July 28, 2016

BUILDING MODIFICATION STATEMENT

BUILDING B5 (PARKING STRUCTURE BUILDING) – Modification SUMMARY

BUILDING B4/B5

B5 GARAGE REDESIGN 8-25-16

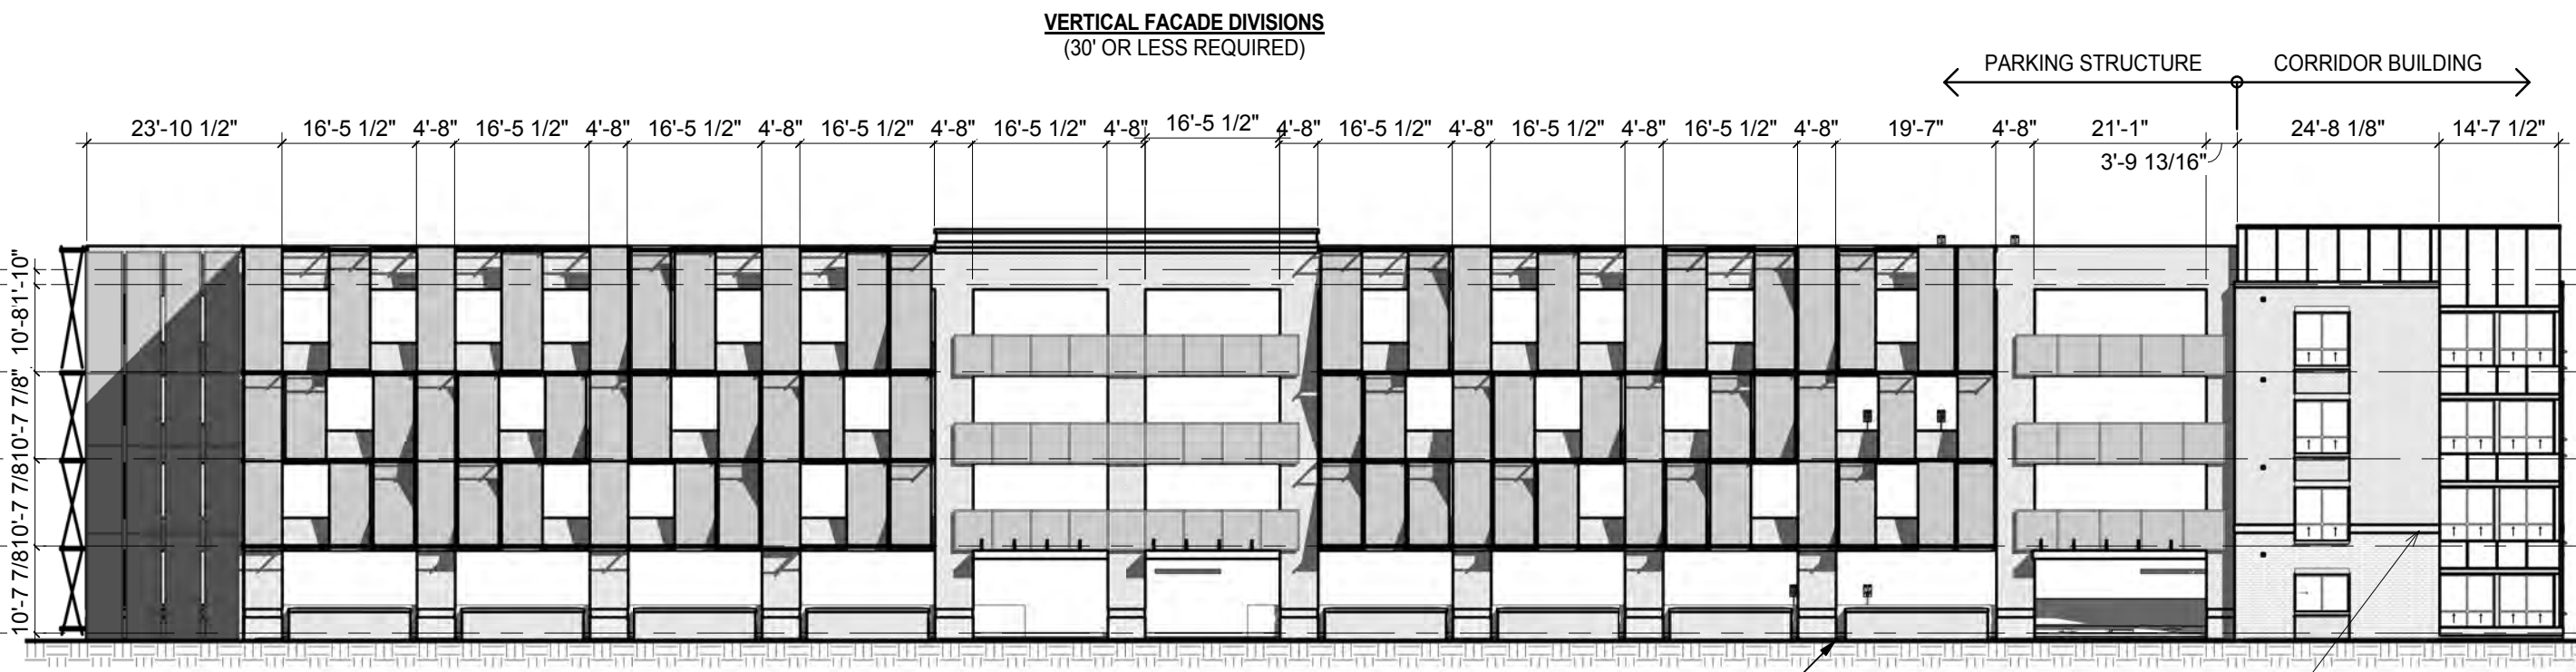
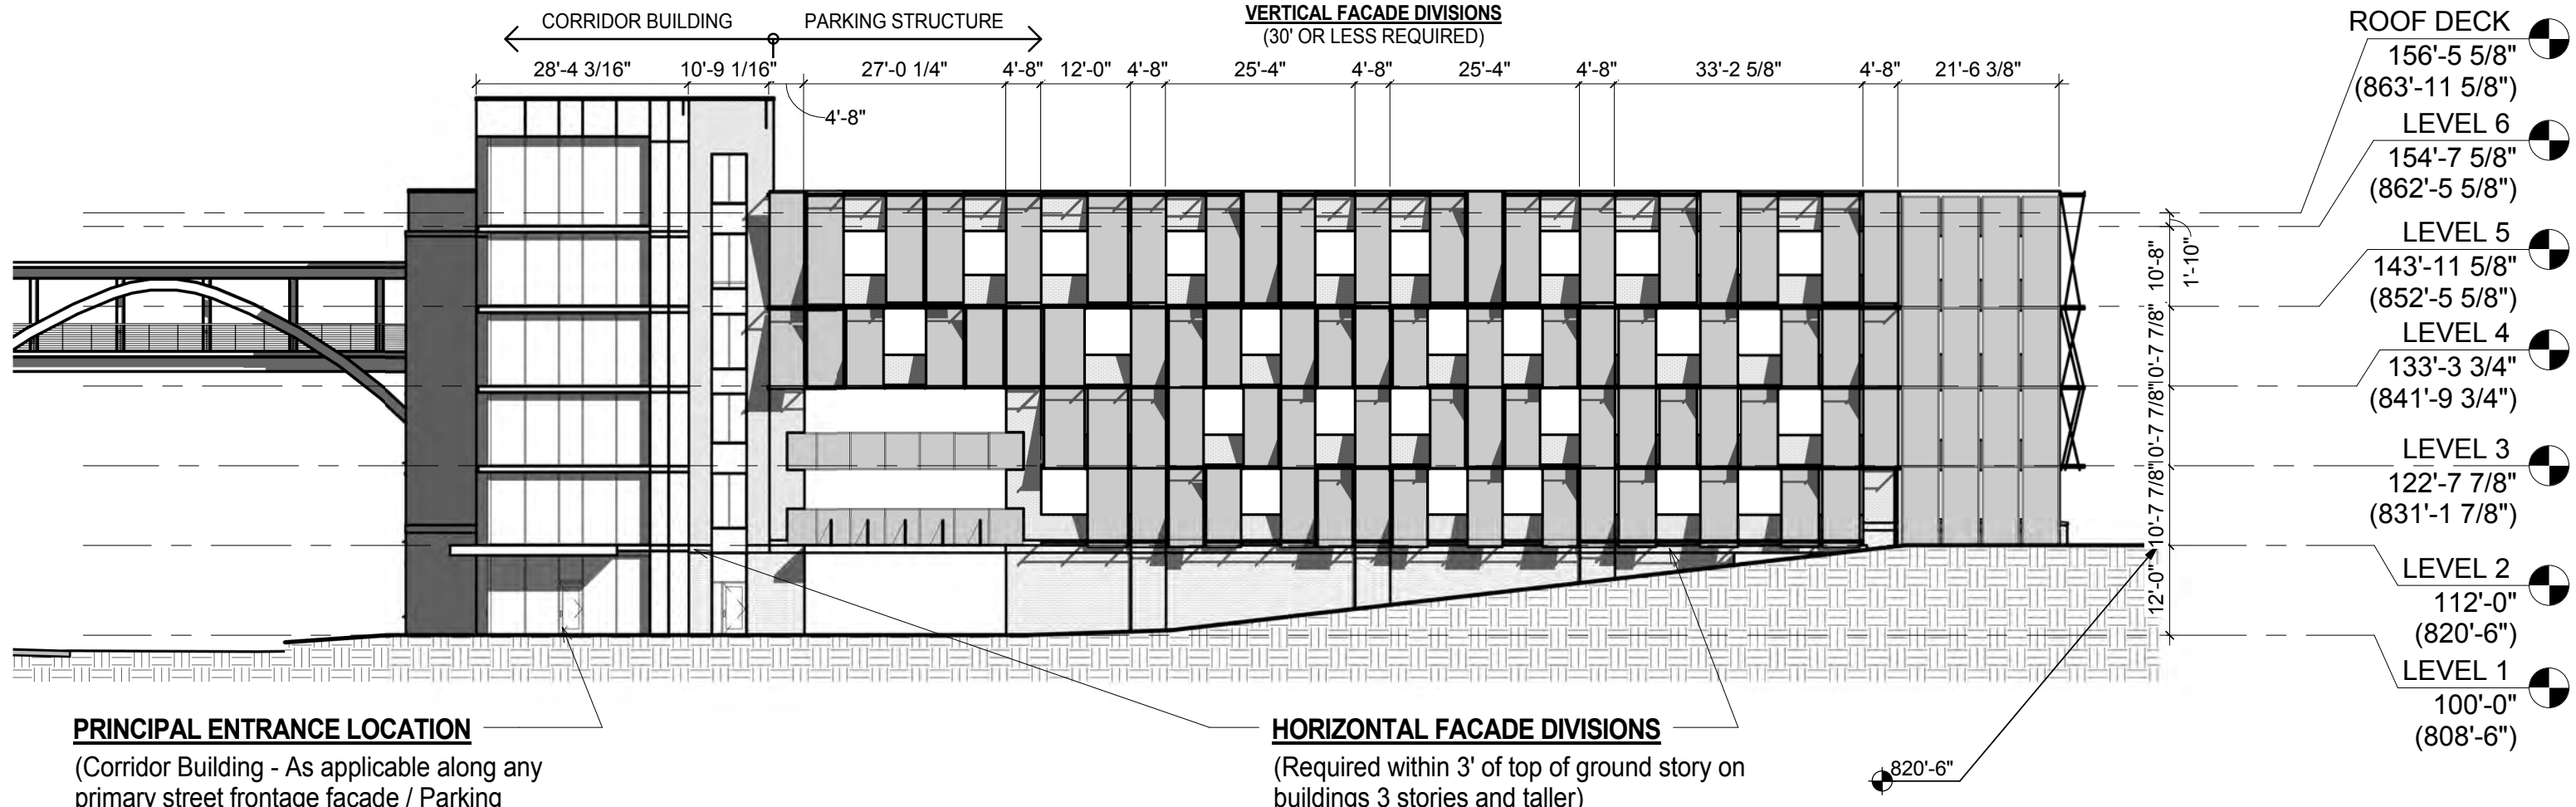
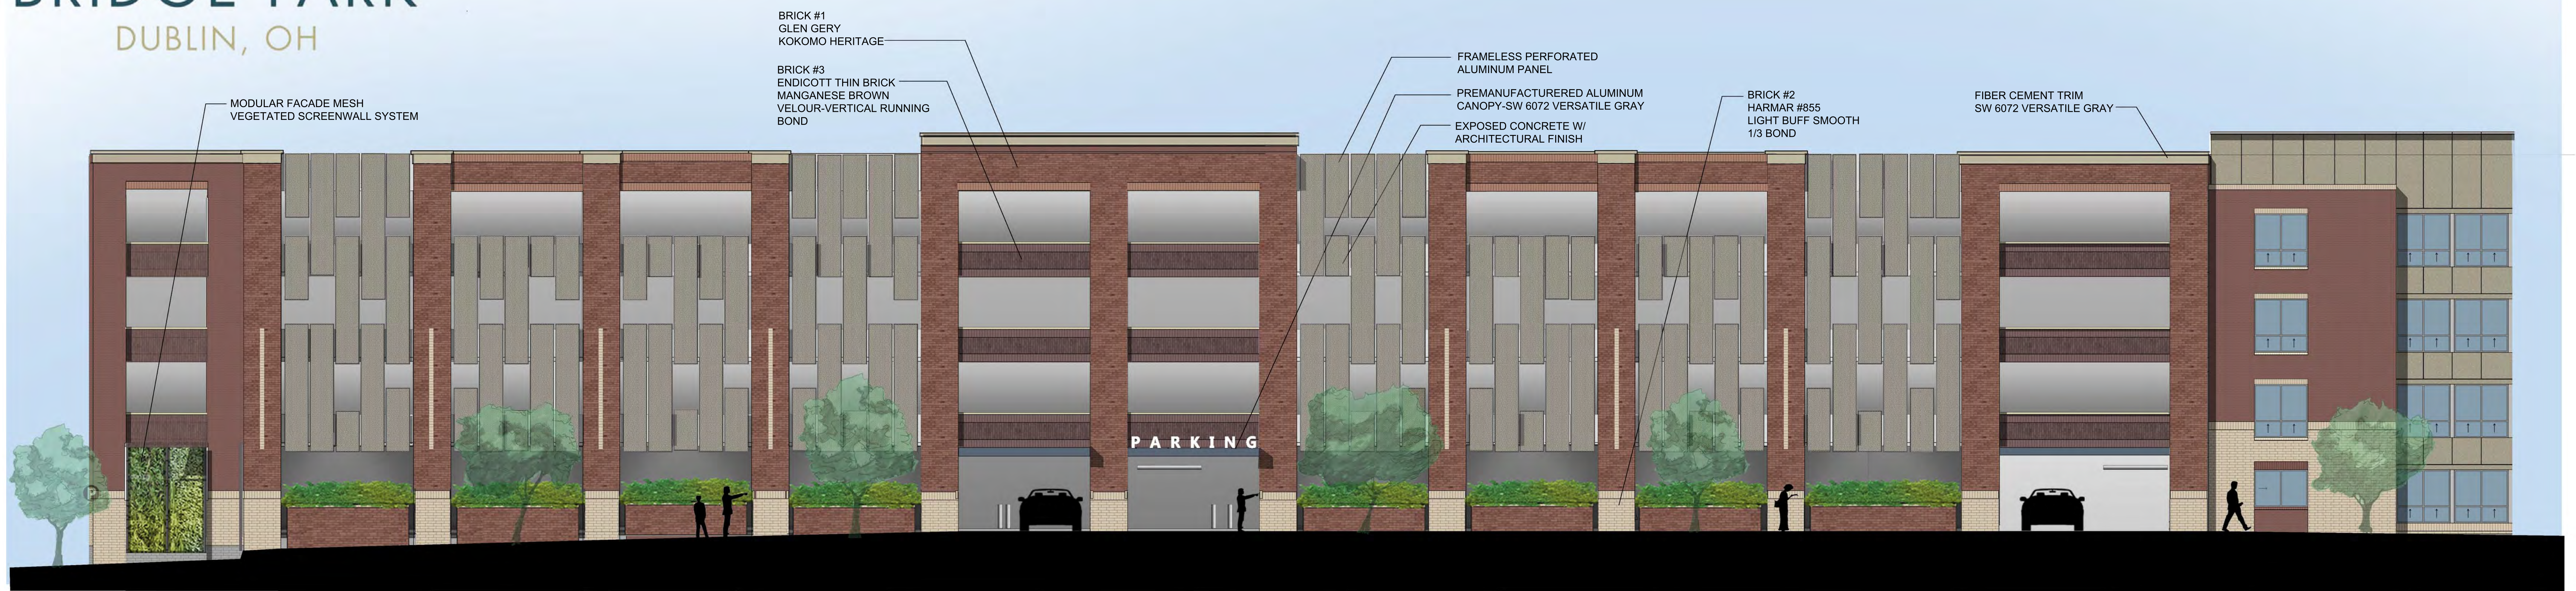
-Change to the elevation: a minor modifications to the east and south facades of building B5

Before –the building was clad in brick with an overlay of stainless steel mesh screen. The southeast corner was a full heights vegetated screen wall. At the entry points the spandrel panels where covered with metal mesh rails

After – the south and east facades of B5 are still clad in brick, but additional masonry detail have been added to the brick facades than there was previously. What has been added are solider course at the top of the large brick openings as well as solider course at the cap of the building. The spandrel panels above the entrances are detailed with a solider course at the top and bottom of the panels and the inside brick runs vertically. The brick piers now have a light color vertical brick accent and are capped off with a fiber cement and alum coping. The spandrels between these piers are exposed architectural concrete with frameless perforated aluminum panels in a staggered vertical pattern covering the majority of the spandrel. The southeast corner has a one story vegetated screen wall that helps to bring down the scale of the building at the corner.

The basic design of the garage facades is similar to the original design but more masonry details have been added and the screens style has changed.

SECTION 6
1 1/2" = 1'-0" SD9

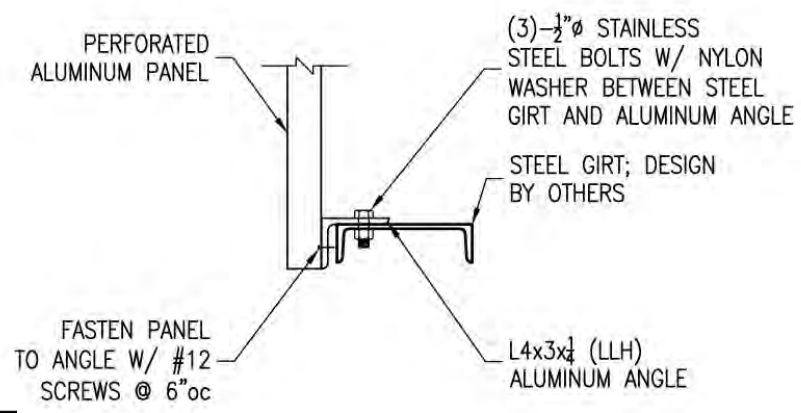
Panels will be a
Gray tone not
Brown
